Stage 05: Draft CUSC Modification Report

Connection and Use of System Code
(CUSC)

CAP189 Standard Gas Insulated Switchgear (GIS) Ownership Boundaries

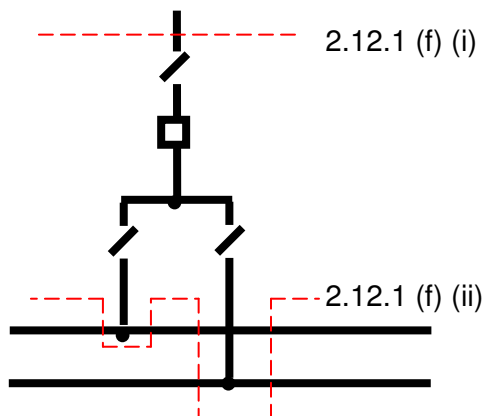
- 7.3 Following the publication of the Draft CUSC Modification Report on 13th July 2011, a response was received from UK Power Networks identifying a significant issue with the proposed legal drafting.
- 7.4 It was identified that the proposed legal drafting will, in most cases, result in a boundary within the GIS (between the circuit-breaker and the circuit disconnecter) and that this was not the intention of the Workgroup. The discussions in the Workgoup related to the boundary being at the cable termination and therefore, UK Power Networks have proposed a text change to cover both scenarios (e.g. where there is a circuit disconnecter and where there is no circuit disconnecter).
- 7.5 A copy of the response can be found in Annex 7.
